**To: All Vendors Bidding on The College of New Jersey
Library Spirit Shop Renovation**

ADDENDUM NO. 2

REFERENCE: The College of New Jersey
Library Spirit Shop Renovation
Bid No. AB260013

2
A101
RCP - LEVEL 1
1/8" = 1'-0"

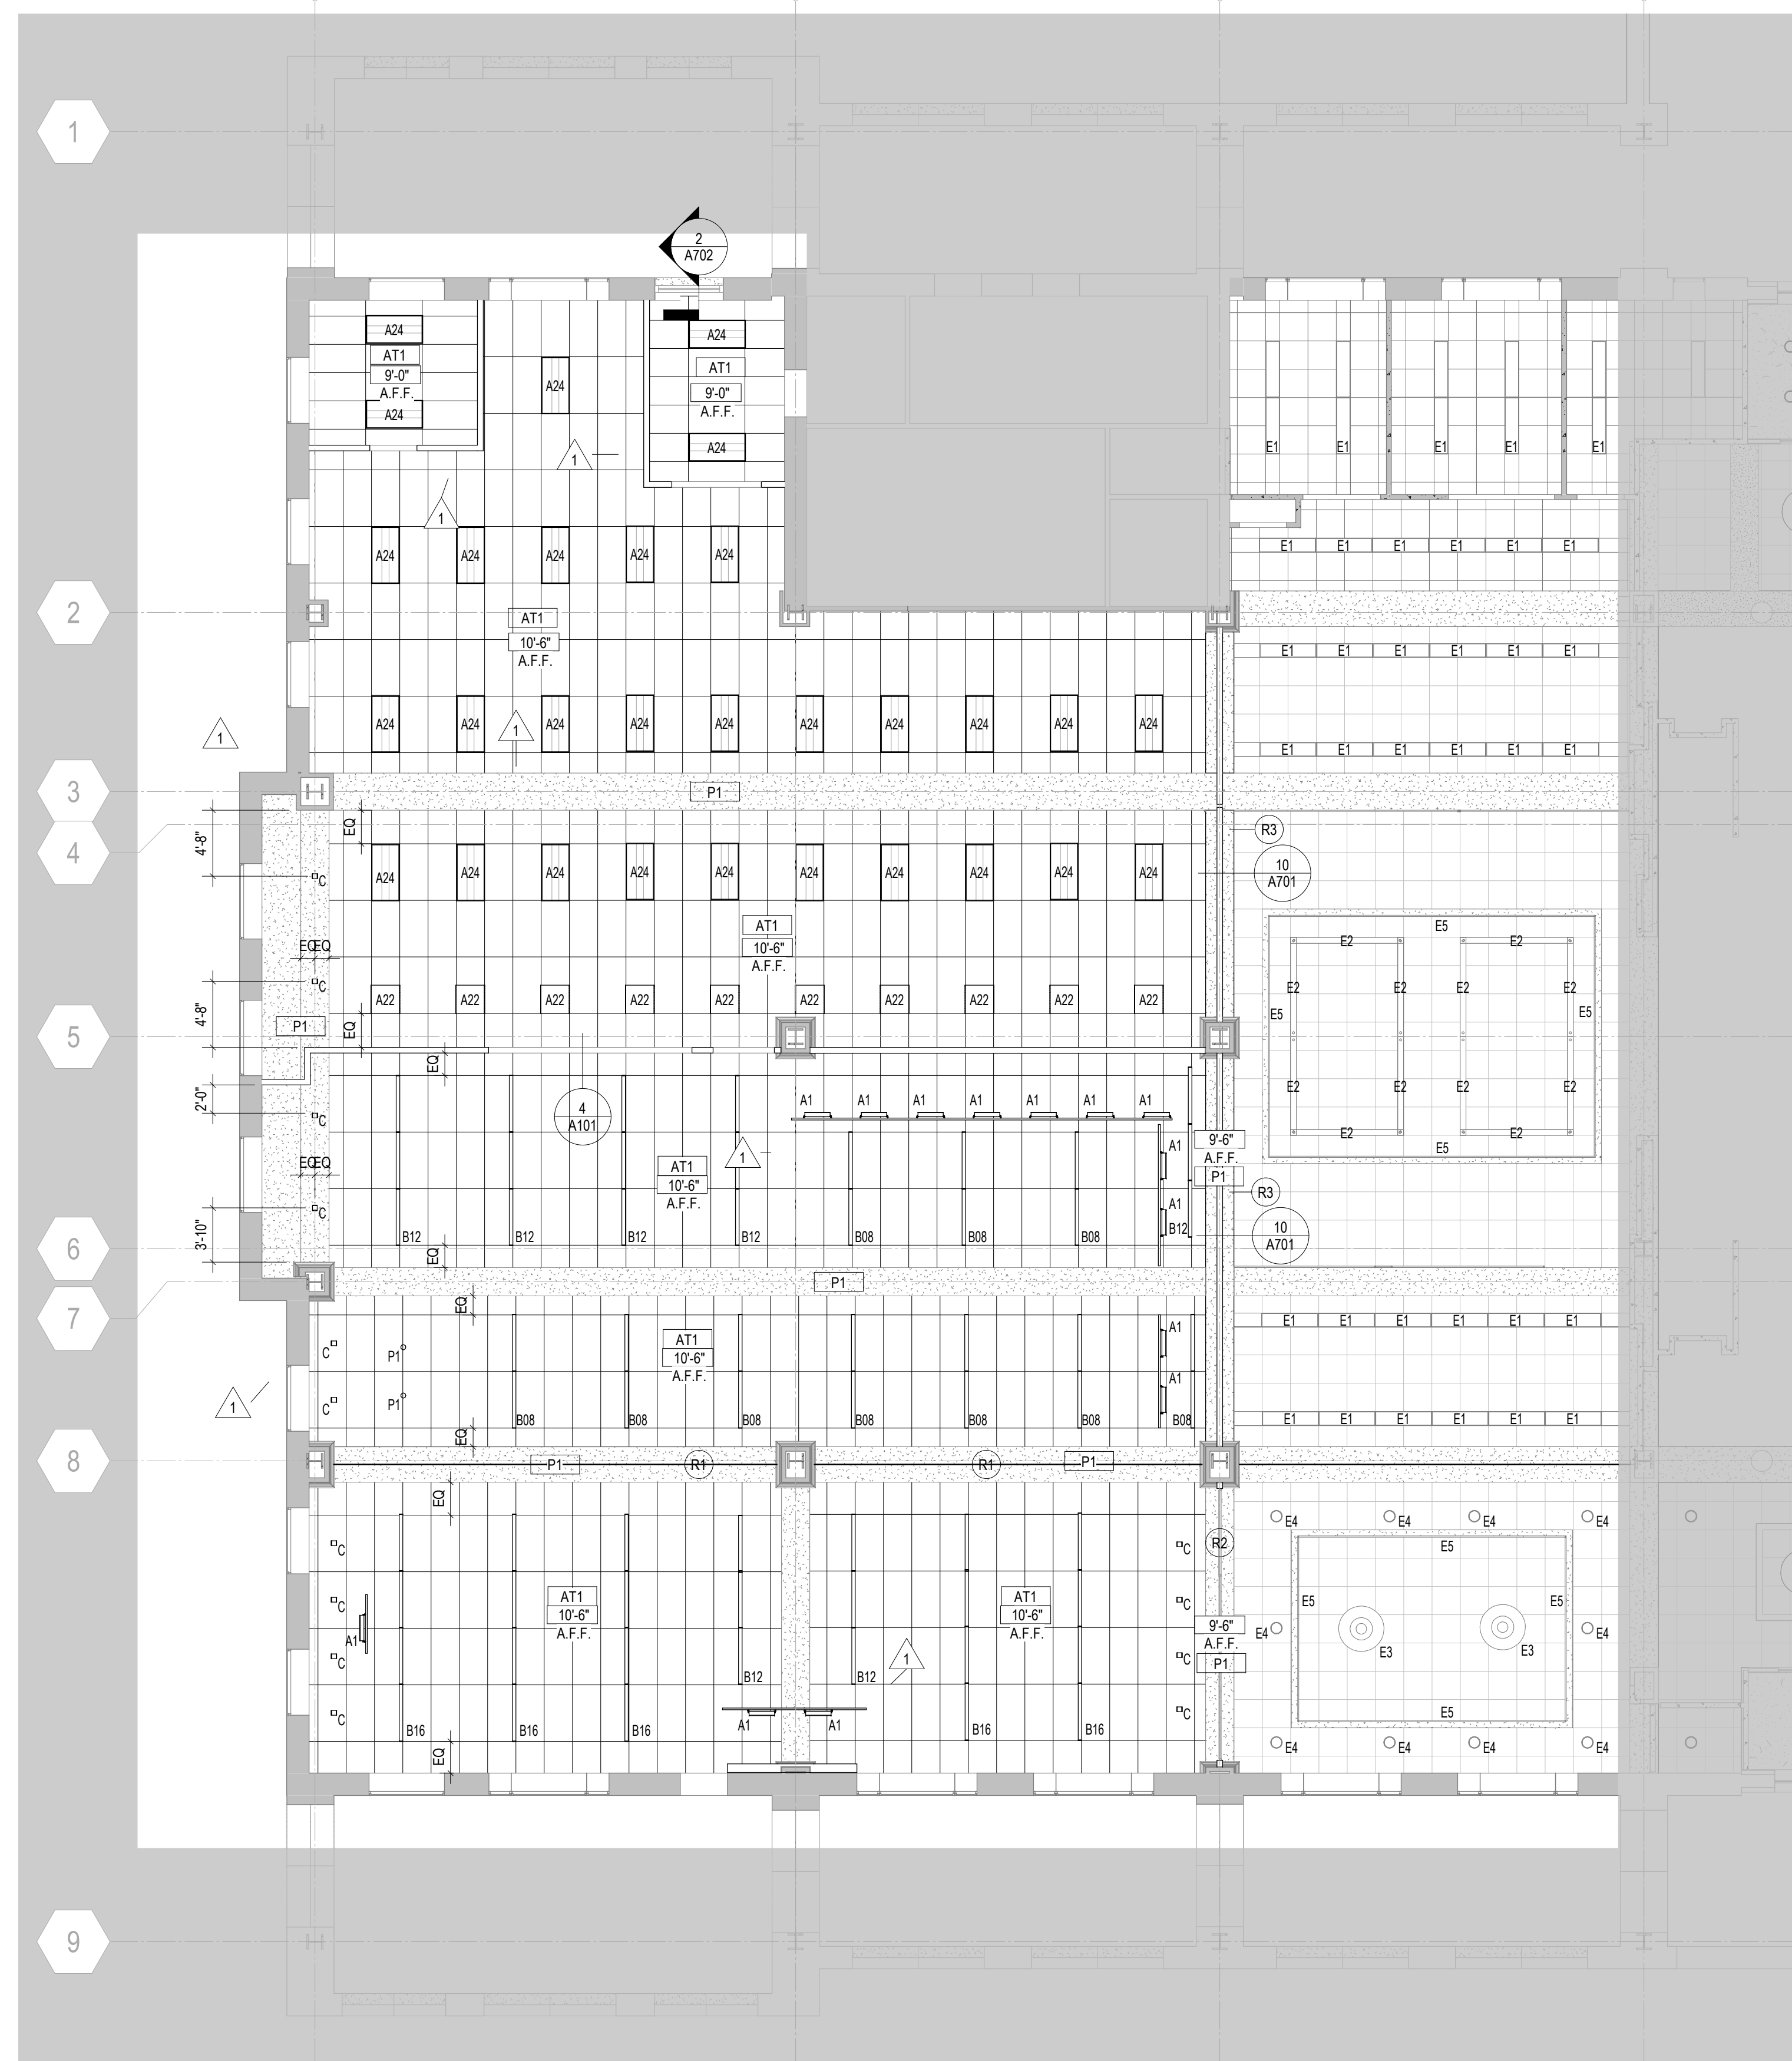
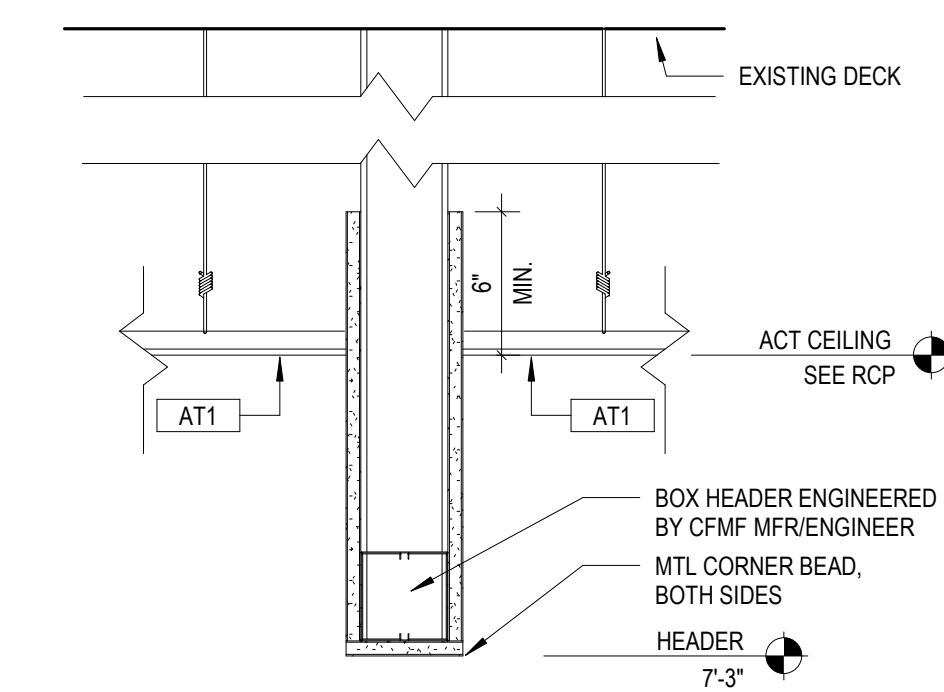
Question 1. Lighting A1 & P1 are not shown on Electrical, as per note on A101 Legend. Please assist with the following:

- Who is to include furnishing for these? Appears to be (15) A1 & (2) P1 Pendants
- Is installation by EC? If so, can make/model be provided for details on installation?
- How are these controlled?

- Revised lighting legend descriptions of A1 and P1 fixtures

Response: The future fixtures are to be supplied by Barnes and Nobles and installed under the scope of a future project. A junction box is to be installed by the Electrical Contractor for this project, in the areas of the future fixtures, noted on the electrical drawings (E301). Future fixtures will be controlled the same as other lights in the vicinity.

A1	ACT MOUNTED LINEAR WASH TRACK LIGHTING FIXTURES TO BE INSTALLED IN FUTURE SCOPE OF WORK, PROVIDED BY BARNES & NOBLES - SEE ELECTRICAL
A24	COLUMBIA LIGHTING: 2X4 BACKLIT FLAT PANEL CB724-A-LSCS-EDD
A22	COLUMBIA LIGHTING: 2X2 BACKLIT FLAT PANEL CB722-A-LSCS-EDD
B08	HE WILLIAMS: 3" WIDE RECESSED LINEAR - 8FT LONG LRX3X-8-L8835-S-DMA-DIM-UNV
B12	HE WILLIAMS: 3" WIDE RECESSED LINEAR - 12FT LONG LRX3X-12-L8835-S-DMA-DIM-UNV
B16	HE WILLIAMS: 3" WIDE RECESSED LINEAR - 16FT LONG LRX3X-16-L8835-S-DMA-DIM-UNV
C	SLG: 6" RECESSED SQUARE DOWNLIGHT DR5 6S LS15 G4 9FK
E1	EXISTING RECESSED 1X4 TO REMAIN
E2	EXISTING LINEAR PENDANT TO REMAIN
E3	EXISTING PENDANT TO REMAIN
E4	EXISTING RECESSED CAN LIGHT TO REMAIN
E5	EXISTING SOFFIT-MOUNTED COVE LIGHT TO REMAIN
X1	EXIT SIGN
P1	PENDANT LIGHT SUSPENDED FROM ACT. FIXTURES TO BE INSTALLED IN FUTURE SCOPE OF WORK, PROVIDED BY BARNES & NOBLES - SEE ELECTRICAL

① LIGHTING - LEVEL 1
1/8" = 1'-0"

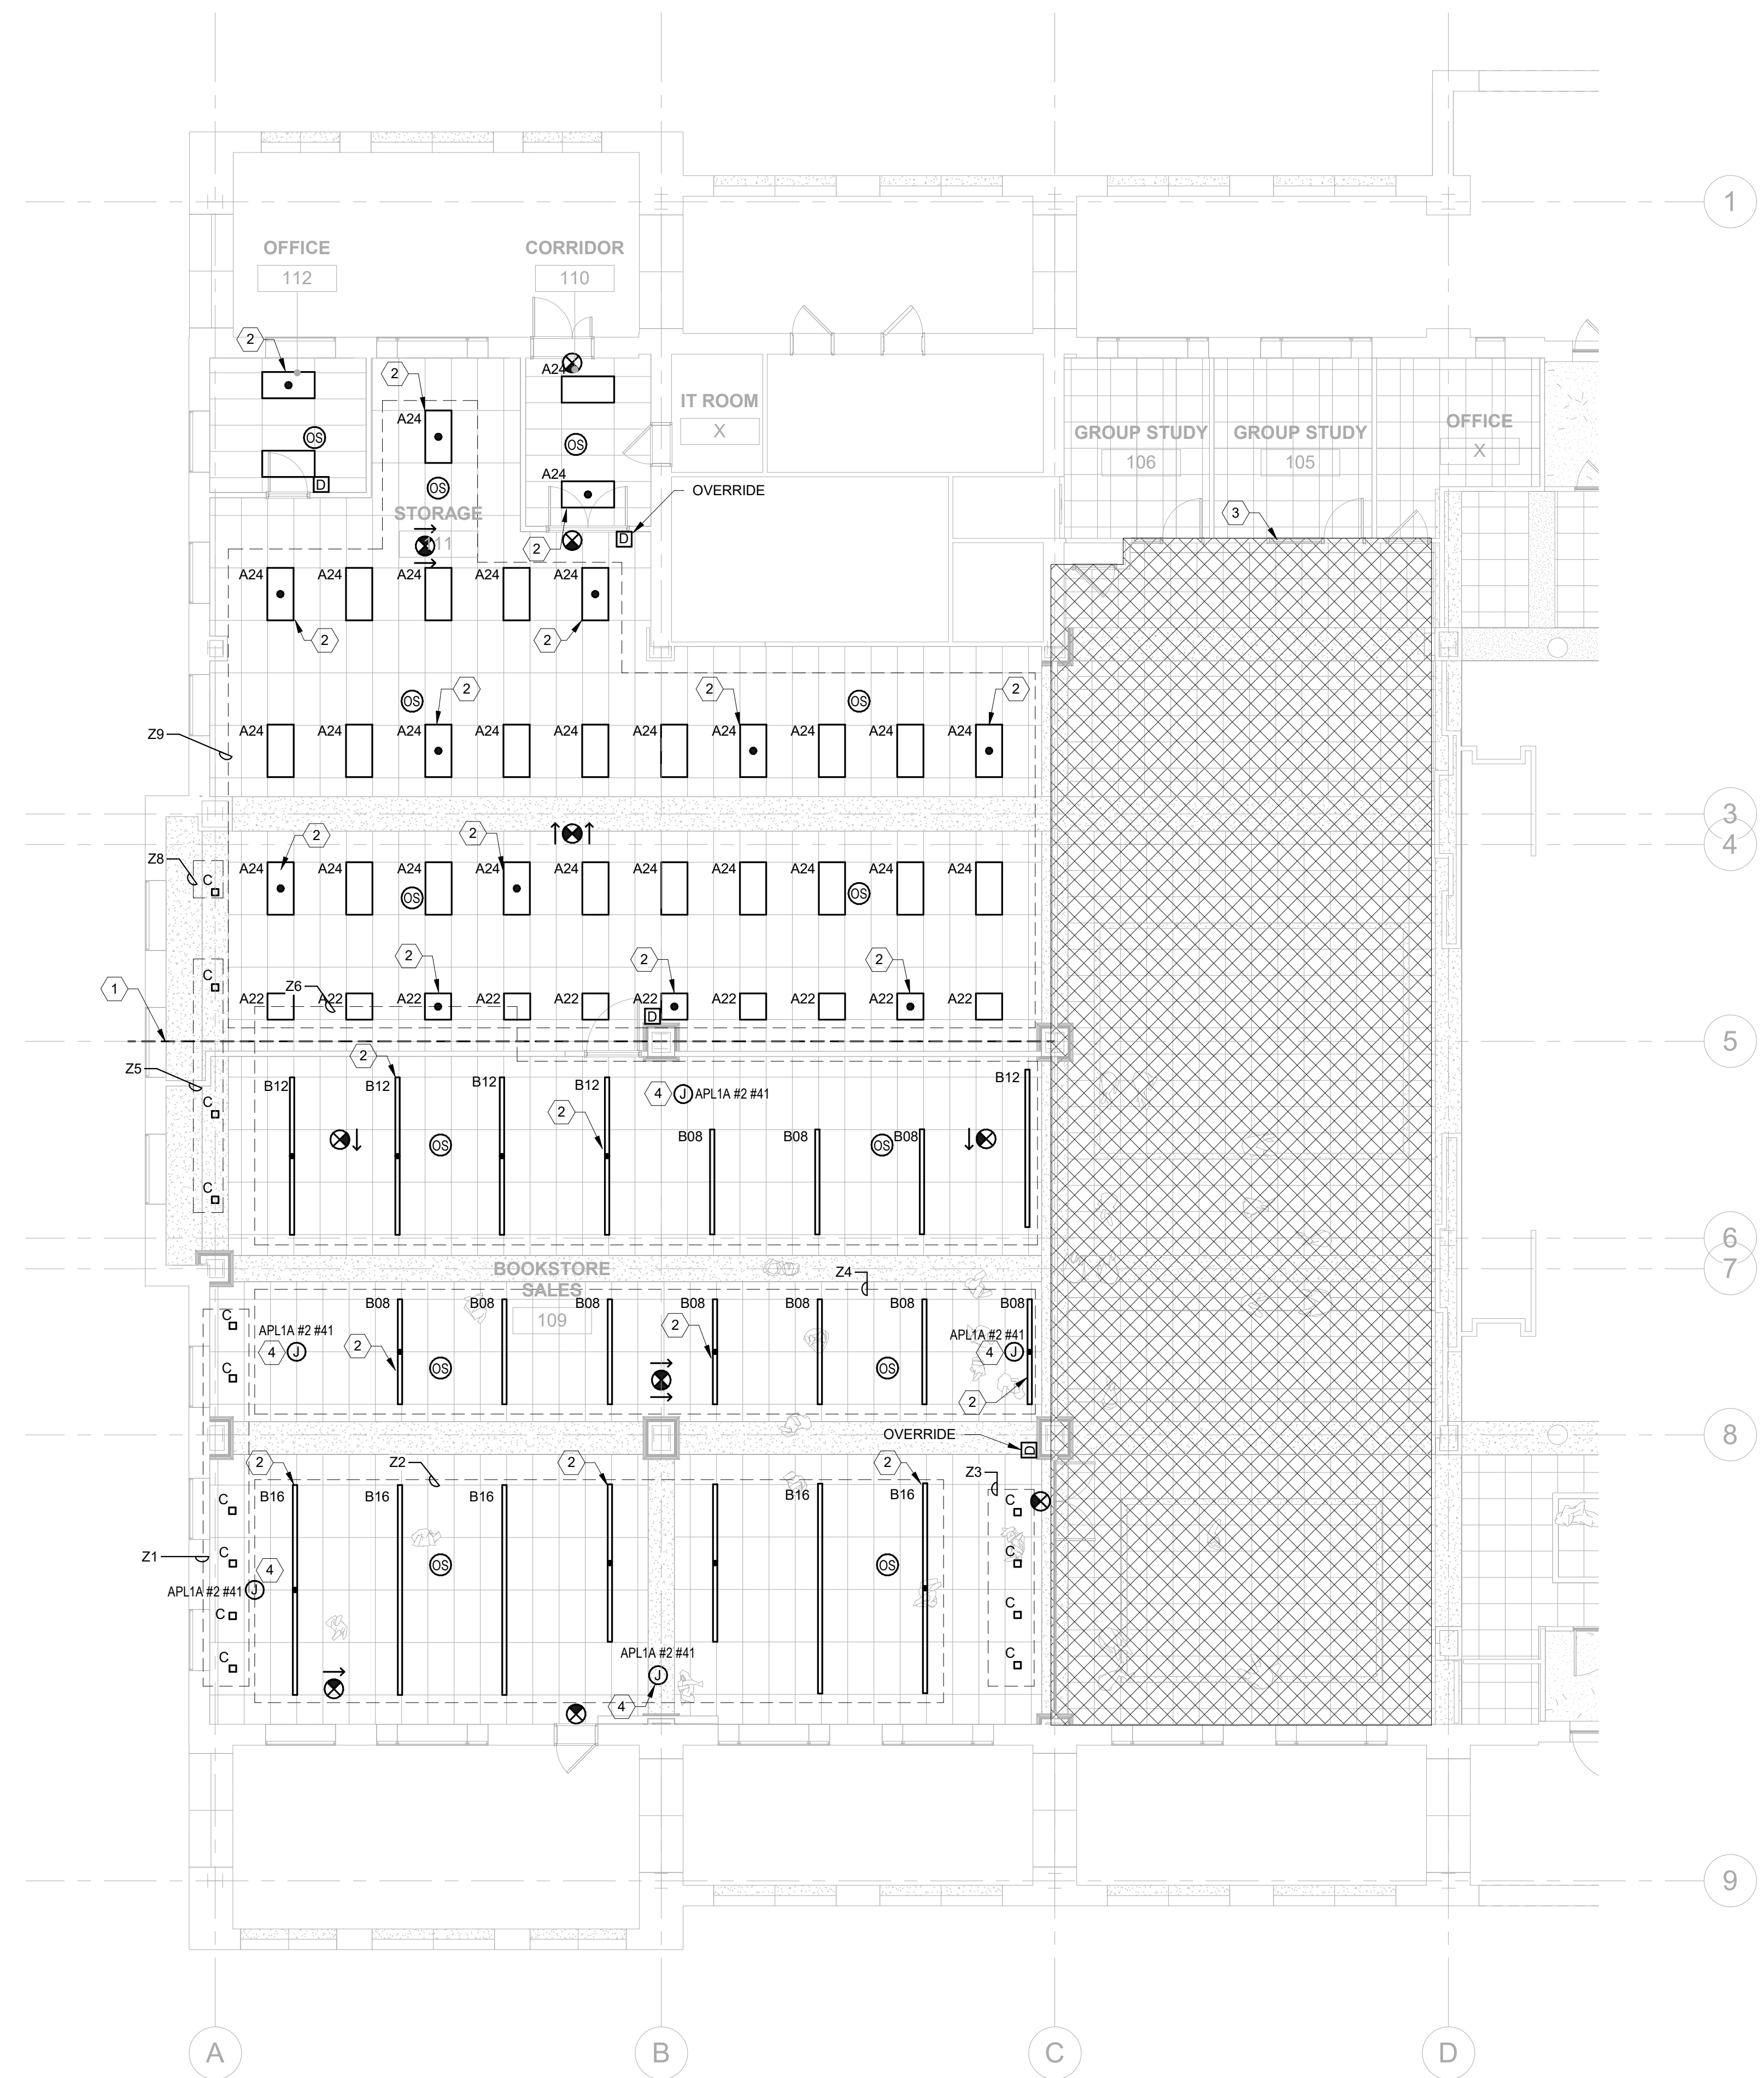
- Revised keynote 4 to clarify that future fixtures are to be supplied by Barnes and Nobles and installed under scope of future project. Future fixtures will be controlled the same as other lights in the vicinity

- ① NORMAL POWER LIGHTING FIXTURES ABOVE DASHED LINE SHALL BE POWERED FROM PANEL LPH1, CIRCUIT 27. NORMAL POWER LIGHTING FIXTURES BELOW DASHED LINE SHALL BE POWERED FROM PANEL LPH1, CIRCUIT 29. REFER TO PANEL SCHEDULE ON E400.
- ② CONNECT LIGHTING FIXTURE TO EMERGENCY LIFE SAFETY CIRCUIT RETAINED DURING DEMOLITION.
- ③ LIGHTING IS EXISTING AND OUTSIDE OF SCOPE.
- ④ PROVIDE 120V LIGHTING BRANCH CIRCUIT AND TERMINATE INSIDE JUNCTION BOX OVERHEAD FOR FUTURE INSTALLATION OF BARNES AND NOBLES PROVIDED FIXTURES, WHICH SHALL BE ON THE SAME SWITCHLEG AS THE OTHER FIXTURES IN THE VICINITY. INSTALLATION OF FUTURE LIGHTS IS NOT PART OF THIS SCOPE OF WORK.
